To: X3T9.2 Membership  
 From: John Lohmeyer, NCR/AT&T Principal X3T9.2 Member  
 Subject: DIFFSENSE Signal Loading Issue

**Figure x-yy: Differential Driver Protection Circuit**

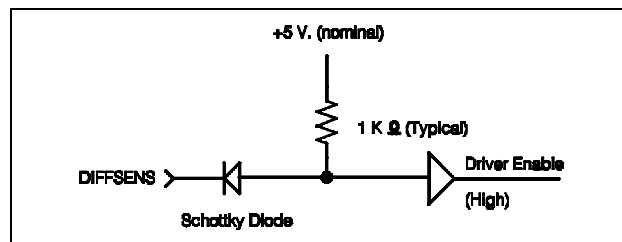
At the September '91 working group meeting I raised an issue concerning powered-off SCSI devices loading the DIFFSENS signal via ESD diodes that may be in their receiver. The working group agreed that the recommended circuit for this signal could be improved by moving the power-isolating diode from the +5 V. input to the DIFFSENS input.

I agreed to prepare a revised figure for the SCSI-3 Physical Interface document. The revised figure along with a suggested paragraph are included below. (Please note that I am not entirely happy with the quality of this figure and I am working with the software vendor to find a solution. However, that is a separate matter.)

The circuit shown in Figure x-yy is the recommended circuit to use on differential SCSI devices to receive the DIFFSENS signal. Other circuits, performing the same function and providing similar isolation of the DIFFSENS signal when the device is powered off, are permitted.
